EPC STORMWATER REVIEW COMMENTS
IN ORANGE BOXES WITH BLACK TEXT

~~Master Development Drainage Plan and
Final Drainage Report~~

Peerless Farms
16975 Falcon Hwy
Peyton, CO 80831

PCD File No. SF242

EXISTING DRAINAGE MAP
 PEERLESS FARMS
 06/24/2024

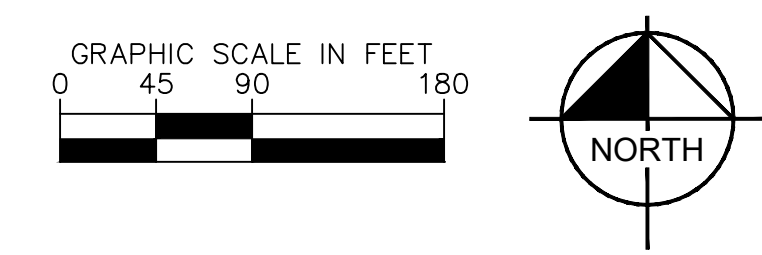
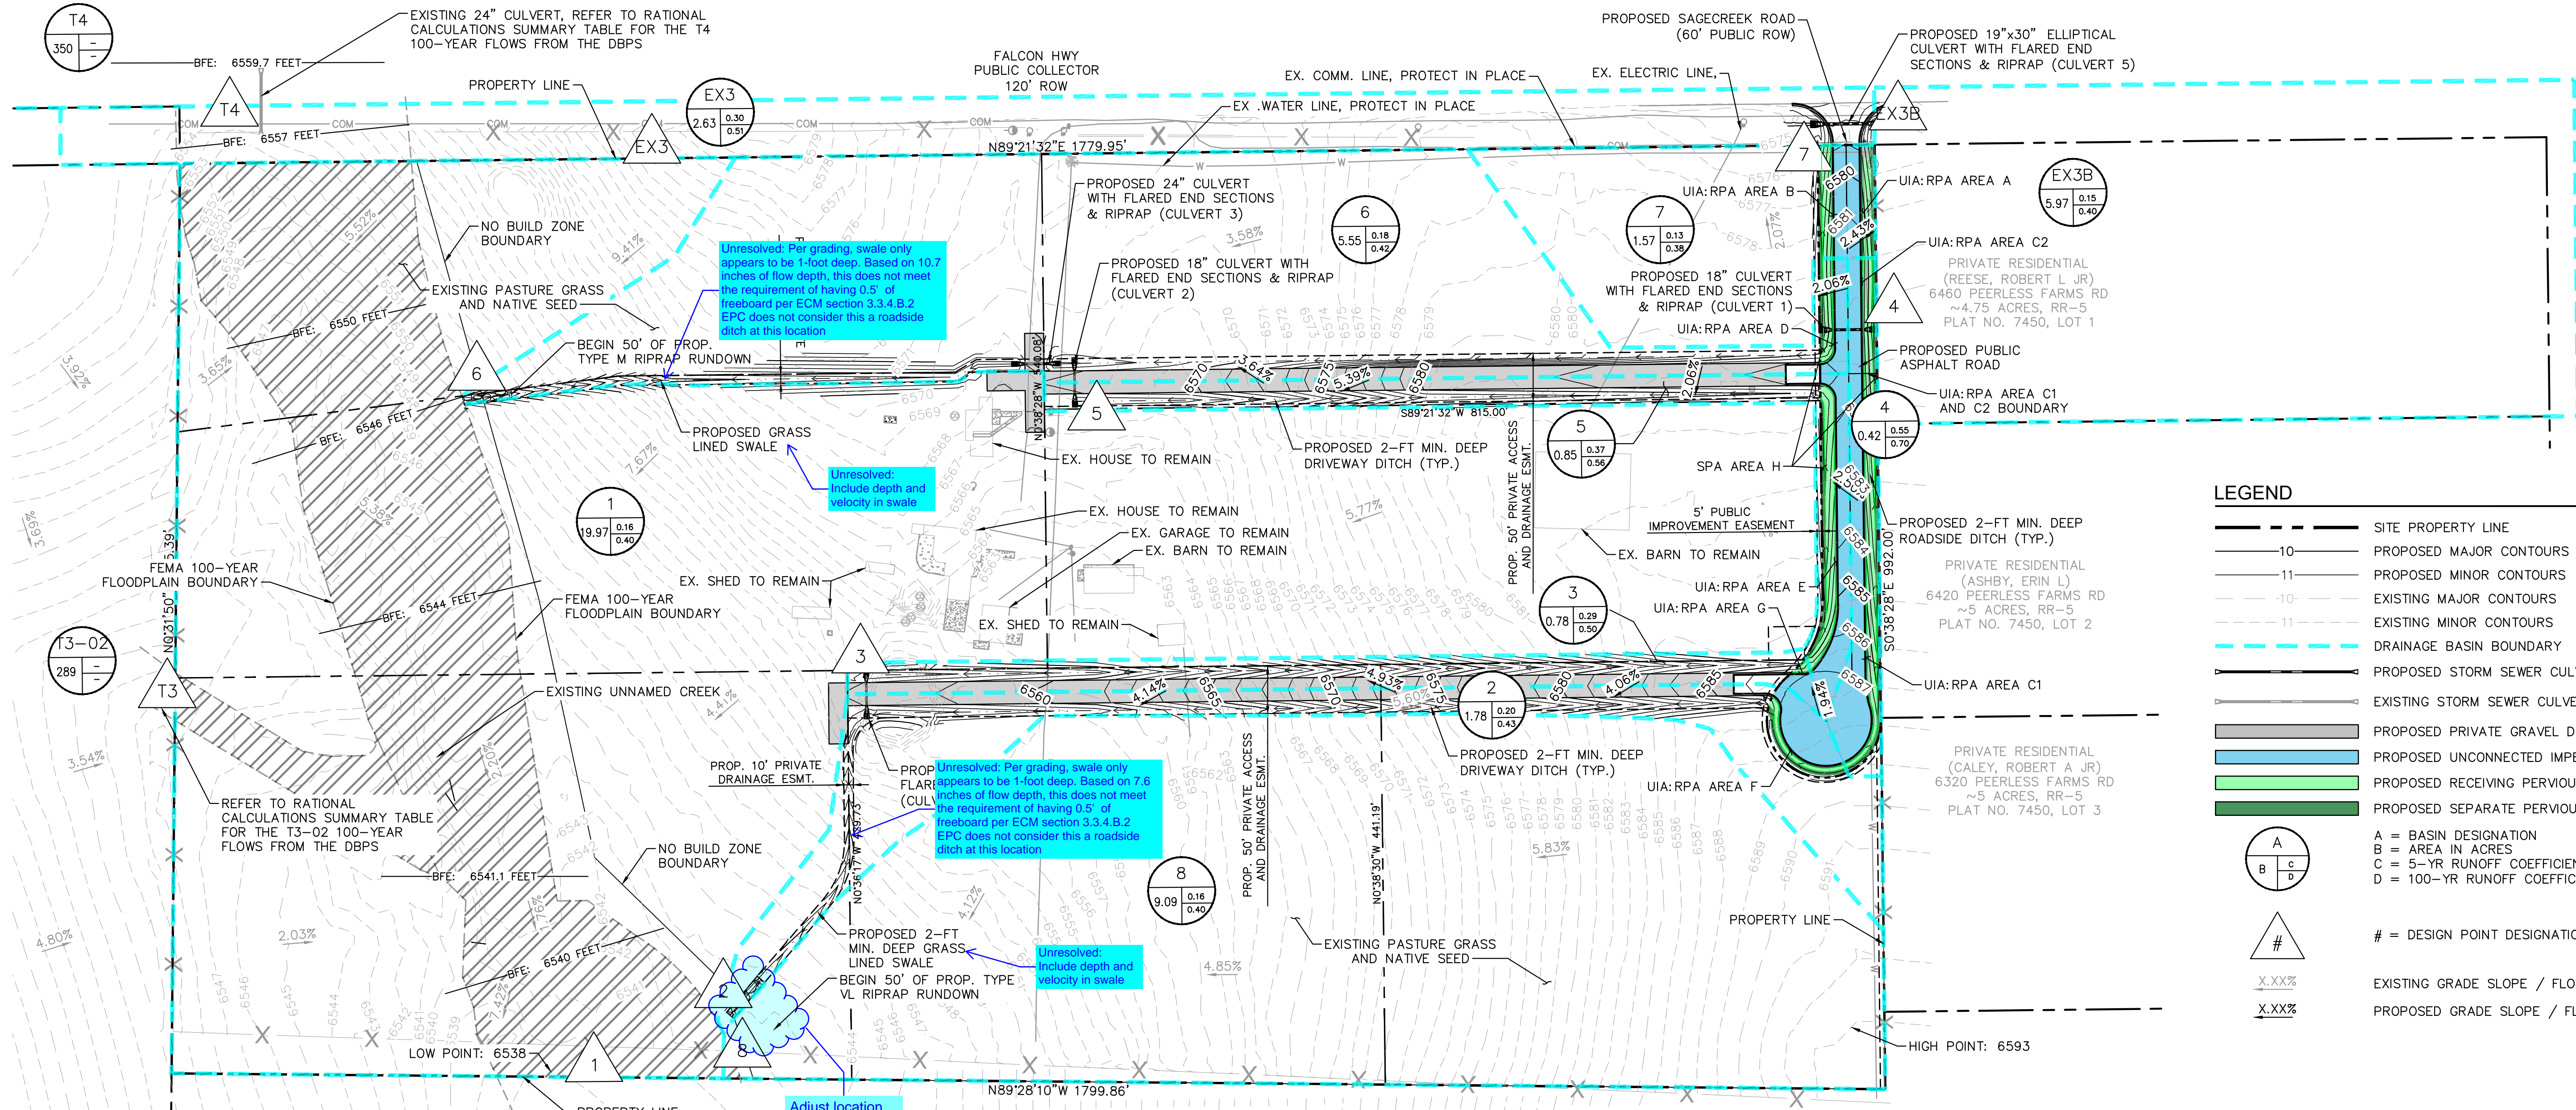
Show flowpaths on map
